**CITY OF RENTON**DEPARTMENT OF COMMUNITY AND
ECONOMIC DEVELOPMENT
REPORT TO THE HEARING EXAMINER, EXHIBITS

Project Name: Quendall Terminals		Project Number: LUA09-151 ECF, EIS, SA-M, SM	
Date of Hearing April 19, 2016	Staff Contact Vanessa Dolbee Current Planning Manager	Project Contact/Applicant Campbell Mathewson, Century Pacific, L. P., 1201 Third Ave, suite 1680, Seattle, WA 98101	Project Location SW ¼ Section 29, Township 24 N, Range 5 E. Parcel 2924059002. South of the Seahawks Training Facility

PROJECT NAME: Quendall Terminals

LAND USE, SHORELINE & MASTER PLAN PERMIT APPLICATION
 CONCEPTUAL UTILITY PLAN

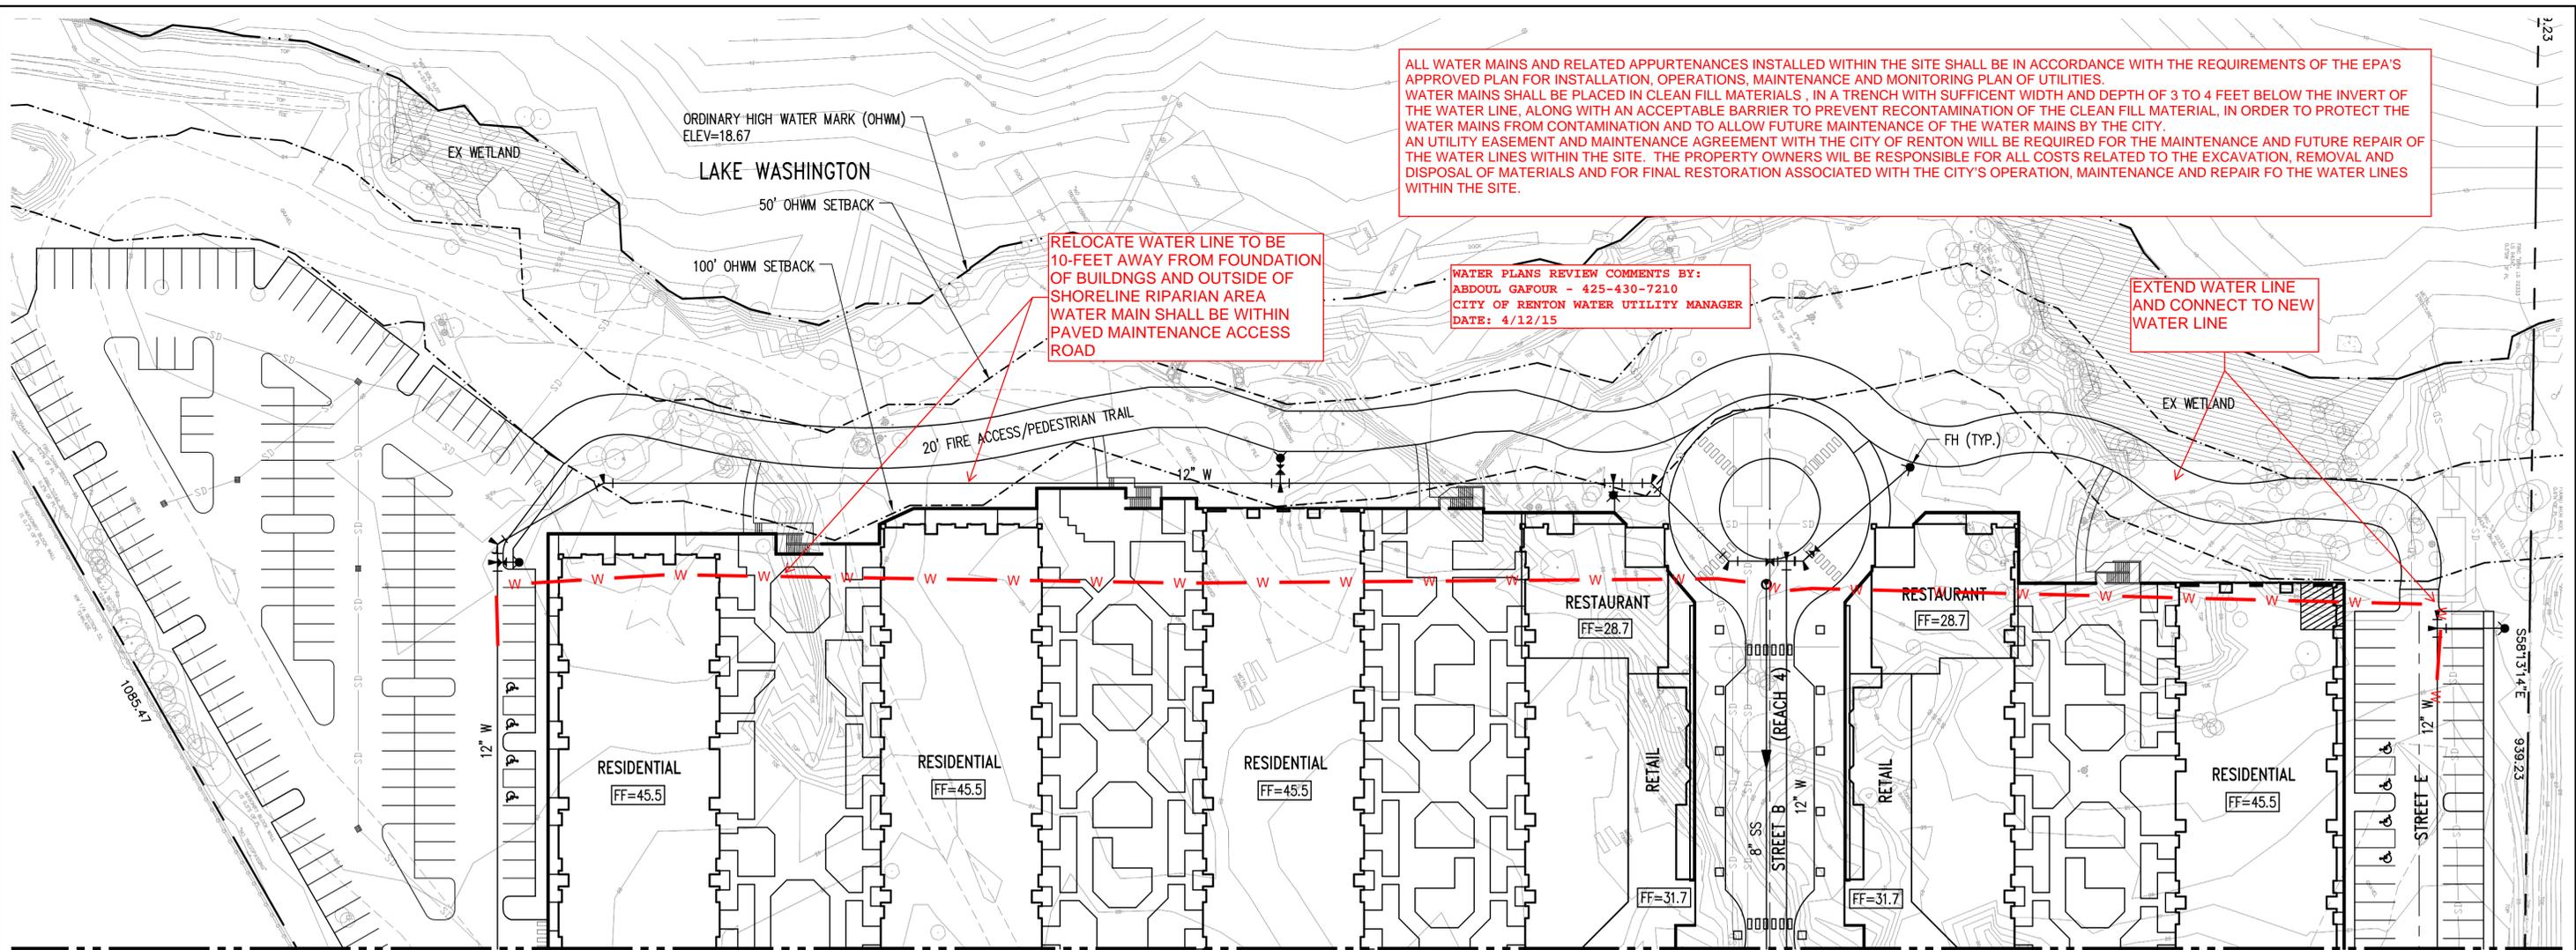
1. The conceptual utility civil plans submitted should be revised to include the following:
 - Relocate about 870 feet of existing 12 inch water main along the property frontage to be within the new access road referred to as Street A. The existing water line cannot be accessible for repair and maintenance due to the location of the new road. Please see the attached water sketch.

ALL WATER MAINS AND RELATED APPURTENANCES INSTALLED WITHIN THE SITE SHALL BE IN ACCORDANCE WITH THE REQUIREMENTS OF THE EPA'S APPROVED PLAN FOR INSTALLATION, OPERATIONS, MAINTENANCE AND MONITORING PLAN OF UTILITIES. WATER MAINS SHALL BE PLACED IN CLEAN FILL MATERIALS, IN A TRENCH WITH SUFFICIENT WIDTH AND DEPTH OF 3 TO 4 FEET BELOW THE INVERT OF THE WATER LINE, ALONG WITH AN ACCEPTABLE BARRIER TO PREVENT RECONTAMINATION OF THE CLEAN FILL MATERIAL, IN ORDER TO PROTECT THE WATER MAINS FROM CONTAMINATION AND TO ALLOW FUTURE MAINTENANCE OF THE WATER MAINS BY THE CITY. AN UTILITY EASEMENT AND MAINTENANCE AGREEMENT WITH THE CITY OF RENTON WILL BE REQUIRED FOR THE MAINTENANCE AND FUTURE REPAIR OF THE WATER LINES WITHIN THE SITE. THE PROPERTY OWNERS WILL BE RESPONSIBLE FOR ALL COSTS RELATED TO THE EXCAVATION, REMOVAL AND DISPOSAL OF MATERIALS AND FOR FINAL RESTORATION ASSOCIATED WITH THE CITY'S OPERATION, MAINTENANCE AND REPAIR OF THE WATER LINES WITHIN THE SITE.

LAND USE, SHORELINE & MASTER PLAN PERMIT APPLICATION
ROADWAY SECTIONS

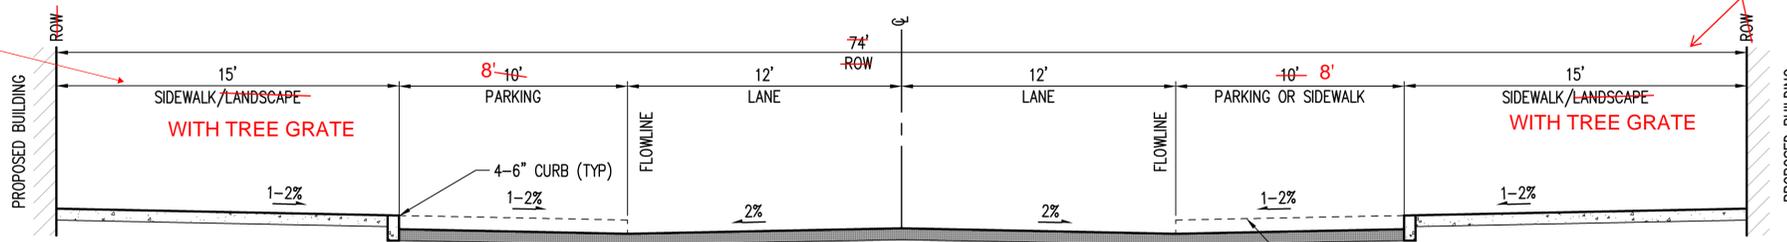
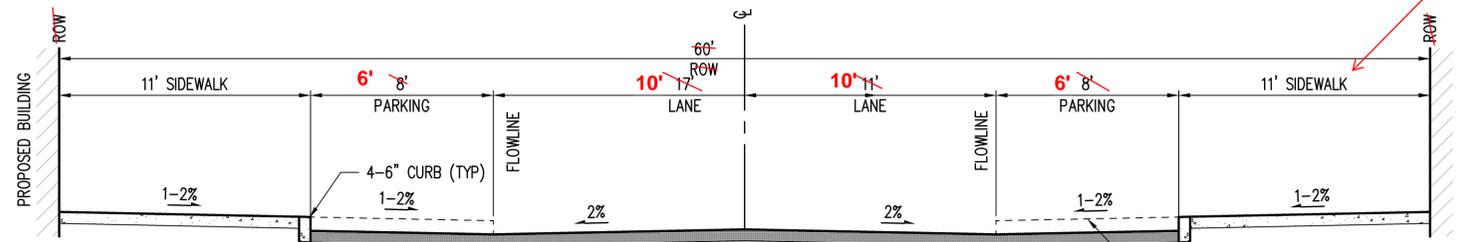
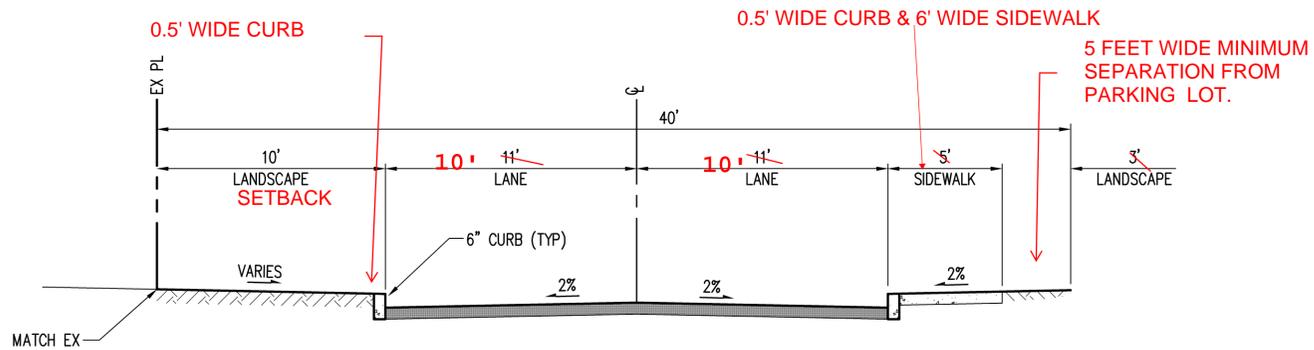
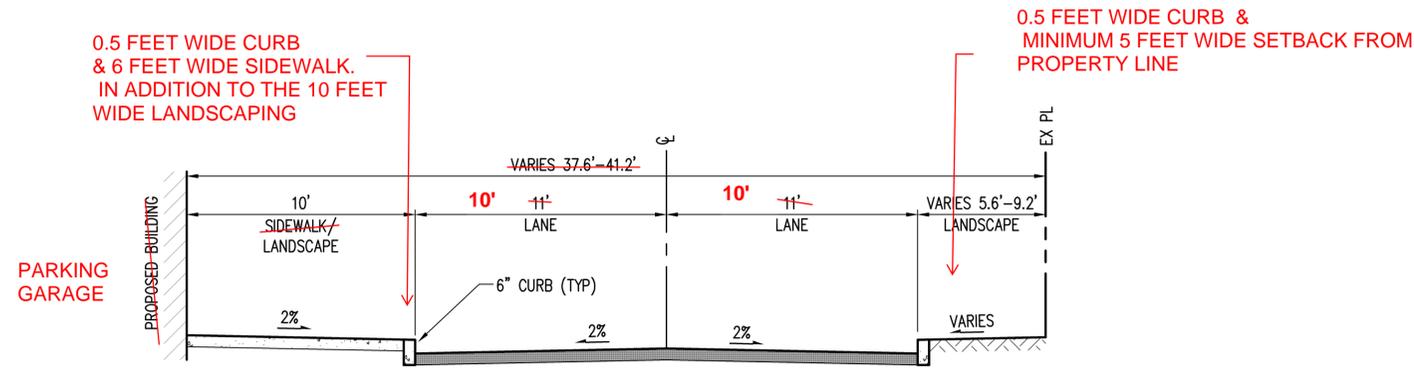
20. The proposed cross section of the internal streets should be revised as per the attached drawings and as per the description

An on site circulation study is required to be provided with the site plan to determine if the proposed 12 feet wide center turn lane is required. If the center turn lane is required, then the street width will have to be changed accordingly. The width of landscaping near the property line is also subject to change based on the site circulation study and/or the proposed use of the building adjacent to Street A.

THE CROSS SECTION ELEMENTS AND WIDTHS ON STREET A WILL VARY DEPENDING ON THE USE OF BUILDINGS ON THE SIDE OF THE STREET & IF THE CENTER TURN LANE IS REQUIRED.

ADDITIONAL 10 FEET WIDE LANDSCAPING IS REQUIRED BETWEEN THE SIDEWALK AND THE BUILDING IF THE BUILDING HAS A PARKING GARAGE ADJACENT TO THE STREET.

THE CROSS SECTION ELEMENTS AND WIDTHS ON STREET B WILL VARY DEPENDING ON THE USE OF BUILDINGS ON EITHER SIDE OF THE STREET.

THE CROSS SECTION ELEMENTS AND WIDTHS ON STREET C WILL VARY DEPENDING ON THE USE OF BUILDINGS ON EITHER SIDE OF THE STREET.

0.5 FEET WIDE CURB, 6 FEET WIDE SIDEWALK, AND 10 FEET WIDE LANDSCAPING NEAR THE BUILDING (IF THE GROUND FLOOR HAS PARKING GARAGE - RESIDENTIAL BUILDING).
